**MONTGOMERY COUNTY HISTORIC PRESERVATION COMMISSION**  
**STAFF REPORT**

<b>Address:</b>	25 Quincy St., Chevy Chase	<b>Meeting Date:</b>	6/14/2017
<b>Resource:</b>	<b>Contributing Resource</b> Chevy Chase Village Historic District	<b>Report Date:</b>	6/7/2017
<b>Applicant:</b>	Bob Shorb (Karl Riedel, Agent)	<b>Public Notice:</b>	5/31/2017
<b>Review:</b>	HAWP	<b>Tax Credit:</b>	N/A
<b>Case Number:</b>	35/13-16V REVISION	<b>Staff:</b>	Michael Kyne
<b>PROPOSAL:</b>	Addition and alterations

**PROPOSAL:**

## PROPOSED SKYLIGHTS (3) ON BACKSIDE OF GARAGE AT 25 QUINCY STREET

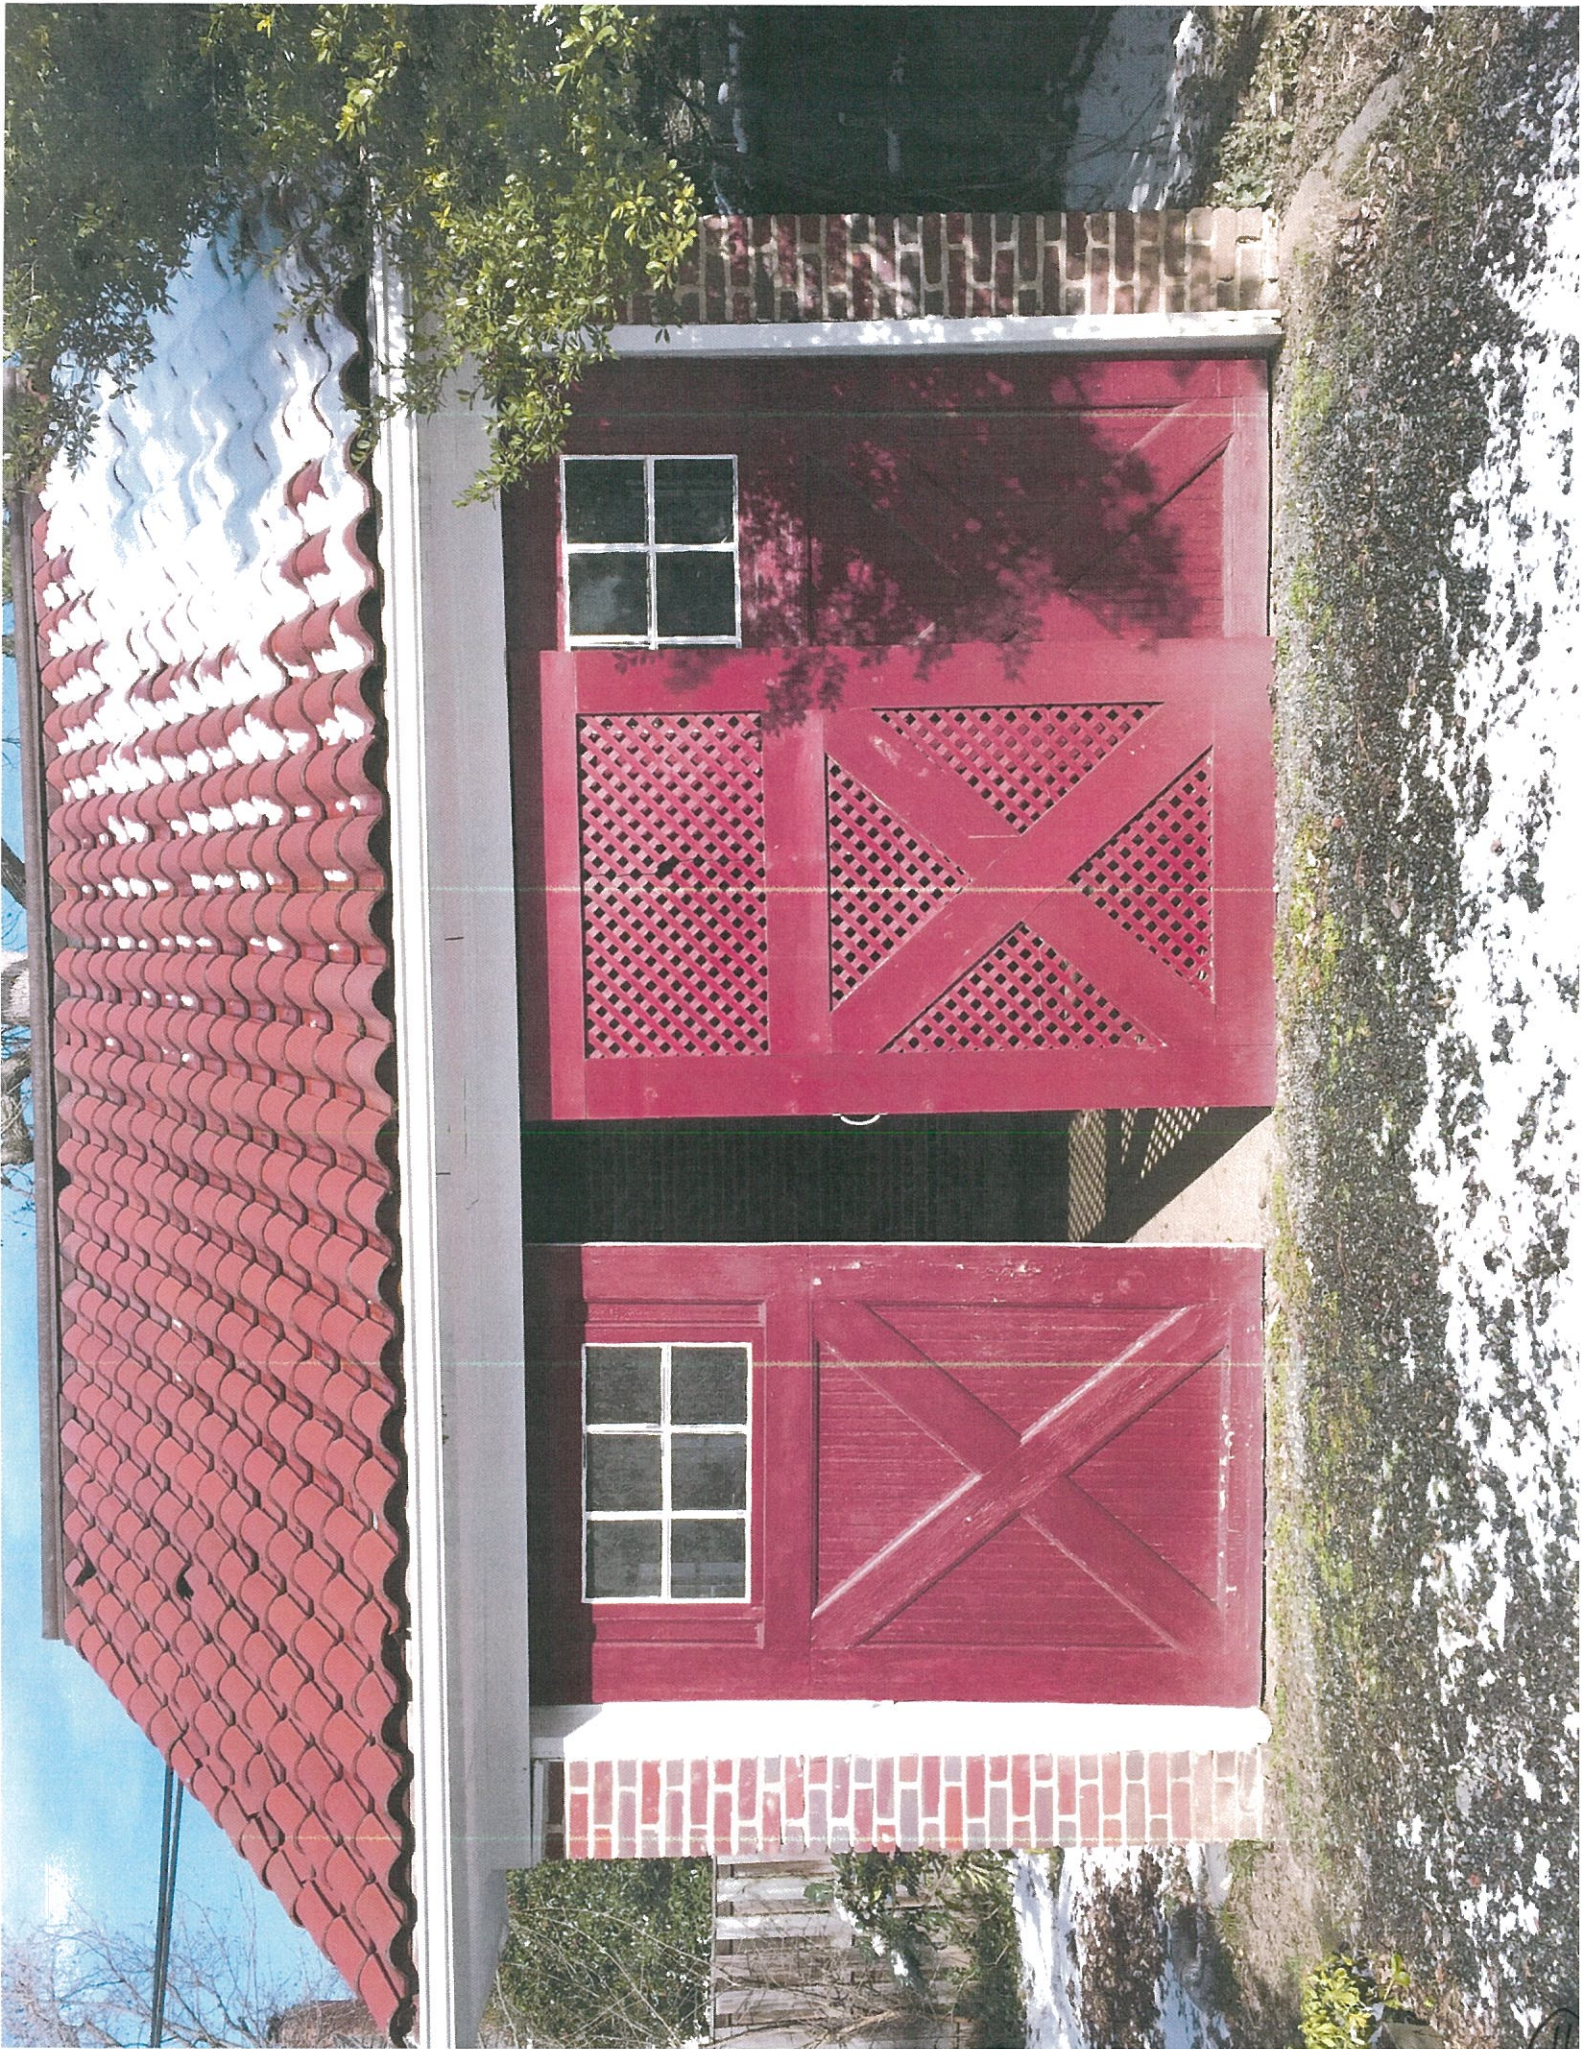
At this time, the applicant proposes to install three (3) new 71" long x 21" wide skylights on the rear-facing slope of the garage roof. The proposed skylights will not be visible from the public right-of-way, and, in accordance with the *Guidelines*, they should be reviewed with lenient scrutiny.

Due to the location and general lack of visibility, the proposed skylights do not have the potential to detract from the subject property or historic district.

SECTION THROUGH  
HALF HEIGHT PARAPET  
WALL AT ROOF OF ADDITION  
(LOOKING NORTH)

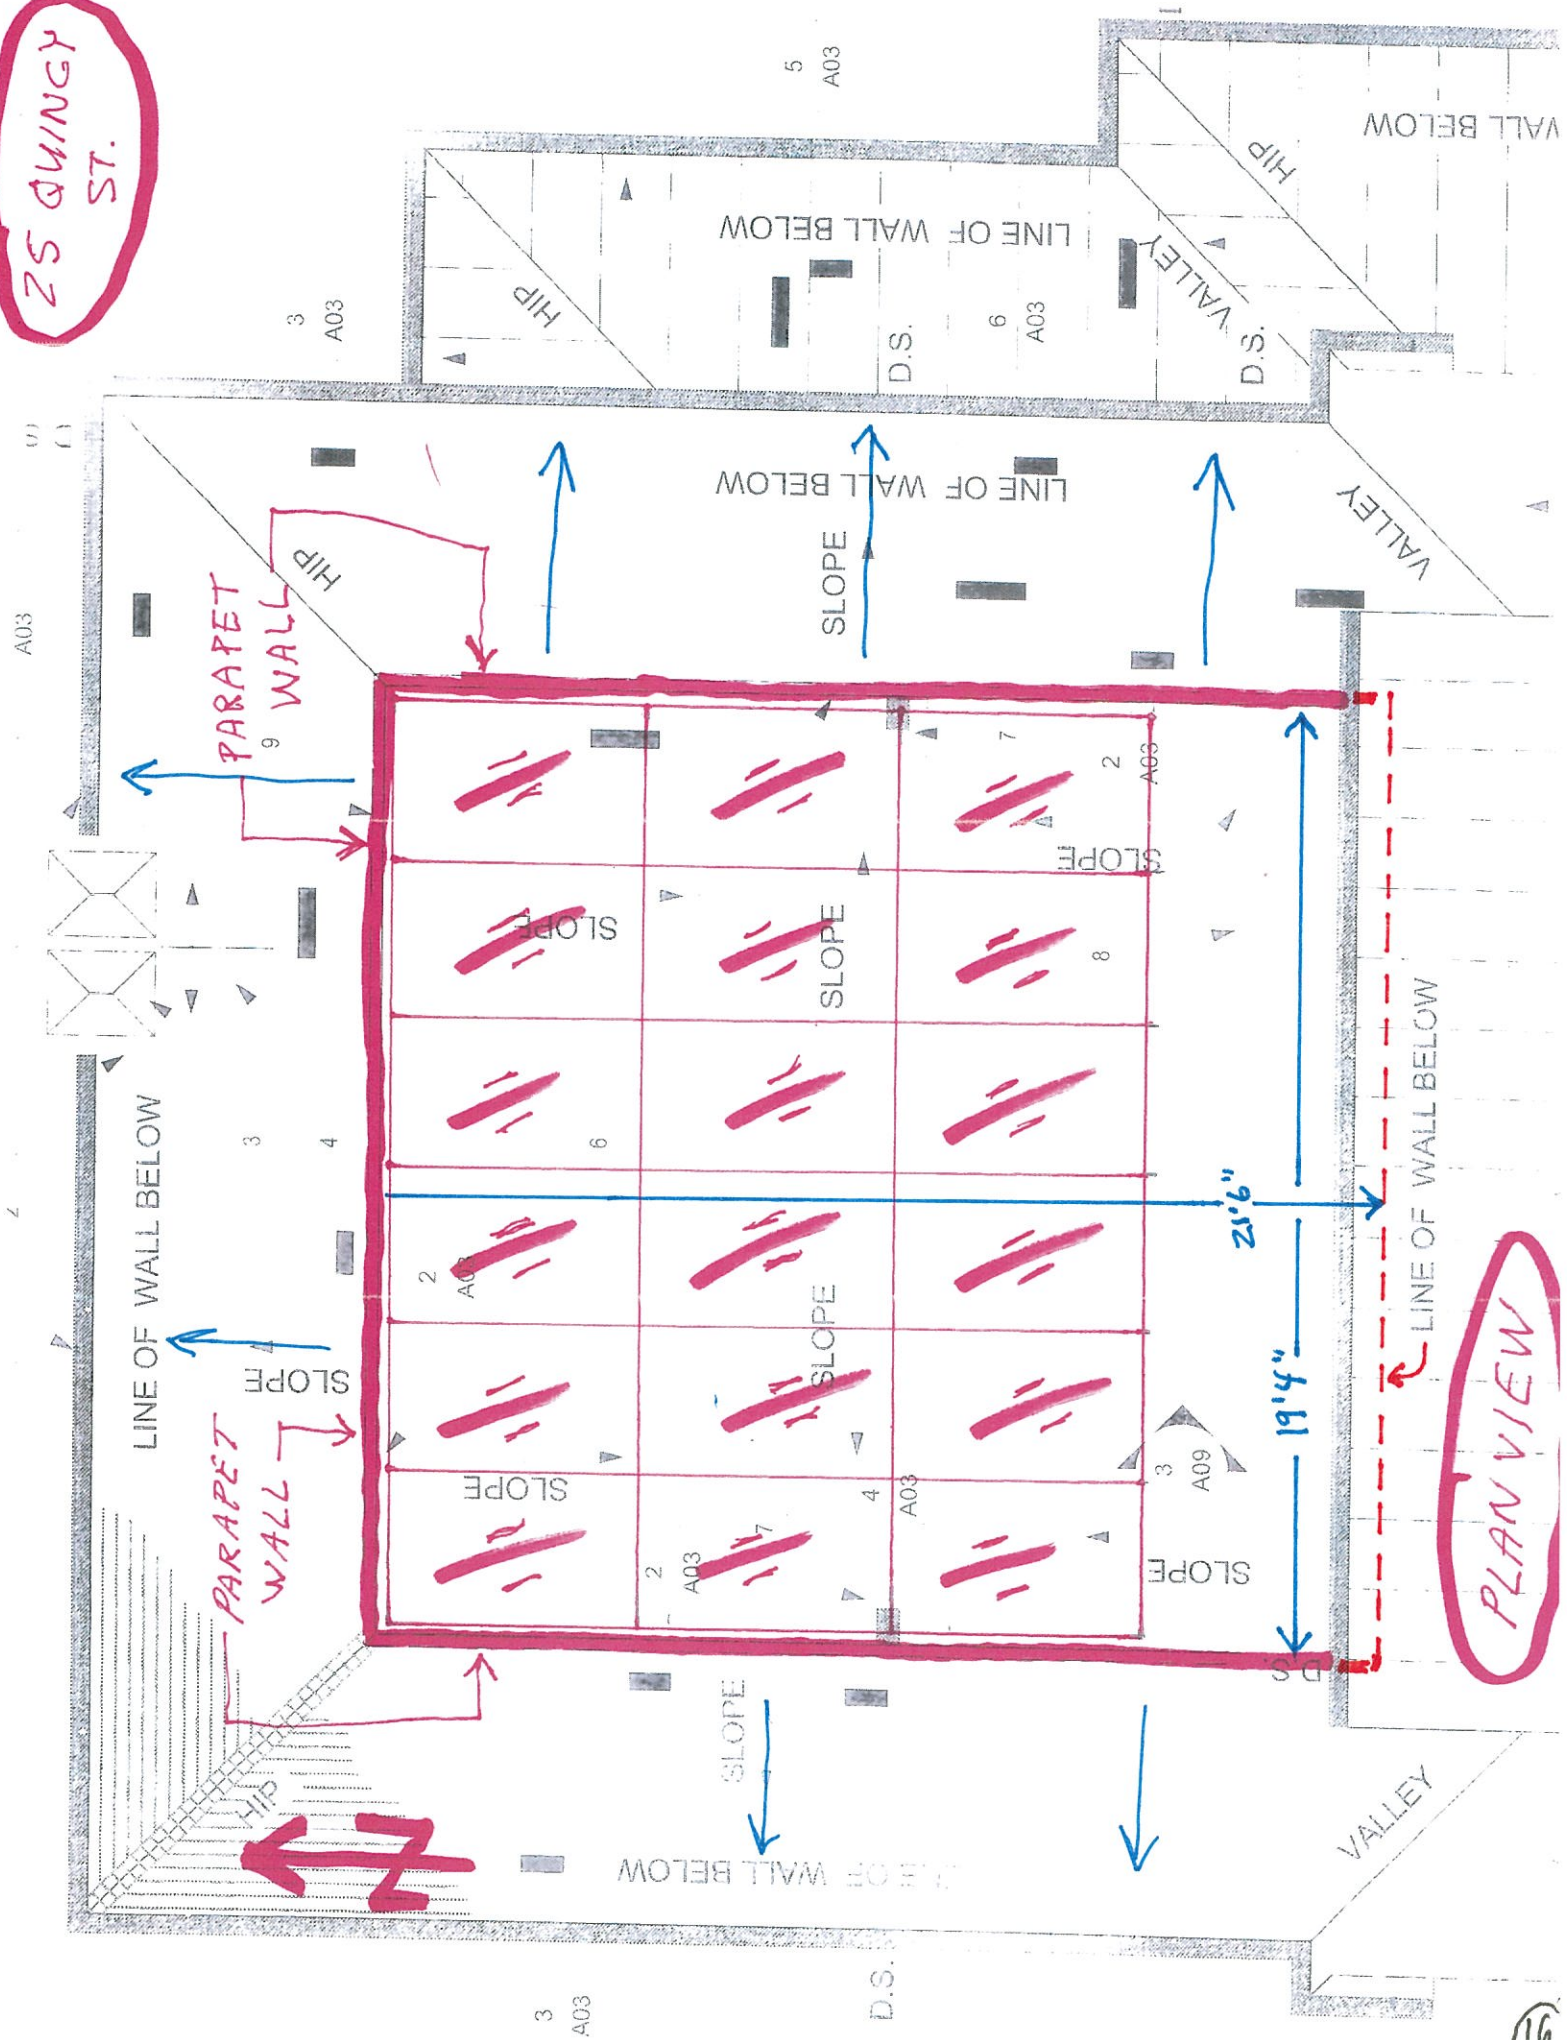
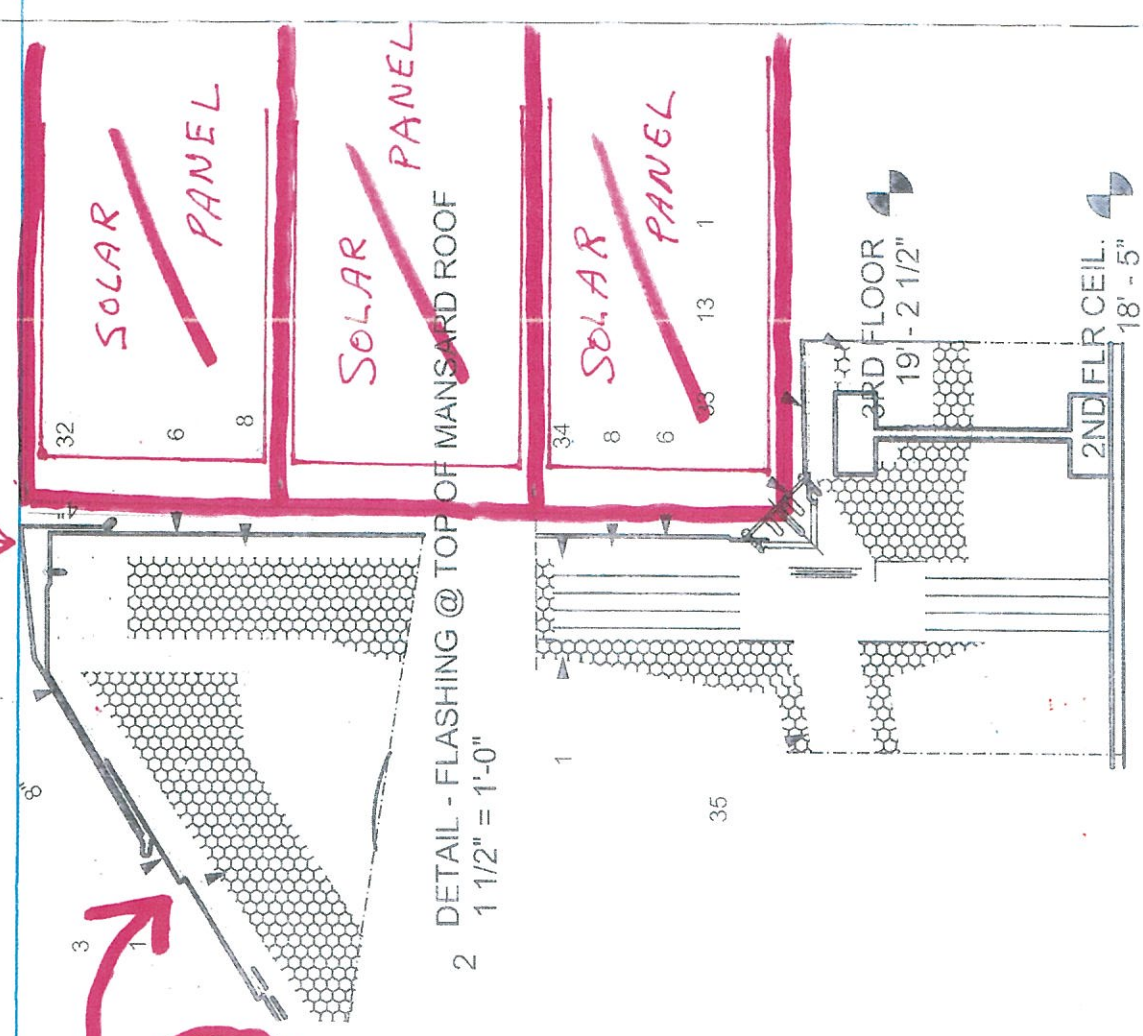
The applicant proposes to install 18 solar panels within the rear roof well at the subject property. The roof well is created by the parapet roof at the rear and sides of the previously approved rear addition. The roof well is 21' 6" long x 19' 4" wide and 32" deep. The highest part of the proposed solar array will be below the flashing of the parapet roof, and the panels will not be at all visible from the public right-of-way.

Staff supports the proposed solar panel installation, finding that they will be in the ideal location, where they have no potential to detract from the subject property or surrounding historic district. The Commission typically requires solar panels to be black with matte black frames, reducing glare and allowing the panels to be more visually compatible with historic features. Staff finds that such a condition may be appropriate in this case, as it will further ensure that the proposed solar panels will not detract from the historic resource; however, the Commission might find that, since the proposed solar panels will not be at all visible, the condition is not necessary.

1. The proposed solar panels will be black with matte black frames.
